**PRODUCT:**

- ST9 Part # 140-0004: Journal Bearing

**MODIFICATION:**

**Pic 1**  
**Journal Bearing With Grooves**

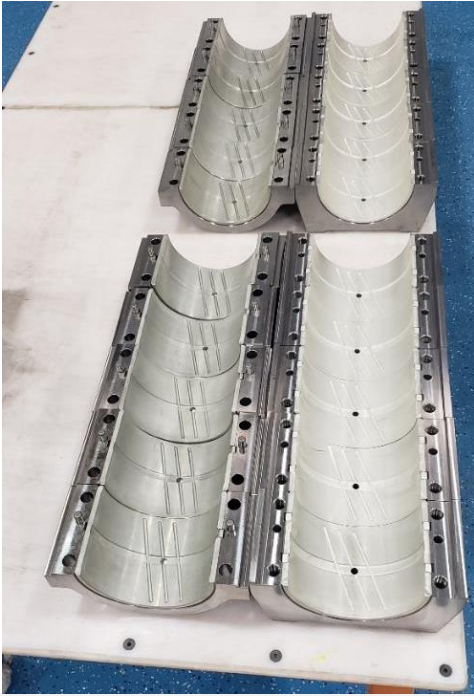
1) Three grooves added to the rod and cap half of the crankshaft journal bearing.

**DETAILS:** To facilitate more even lubrication across the crank journal, three oil grooves were added to the rod and cap halves of the journal bearings. Both sides have the same part number.
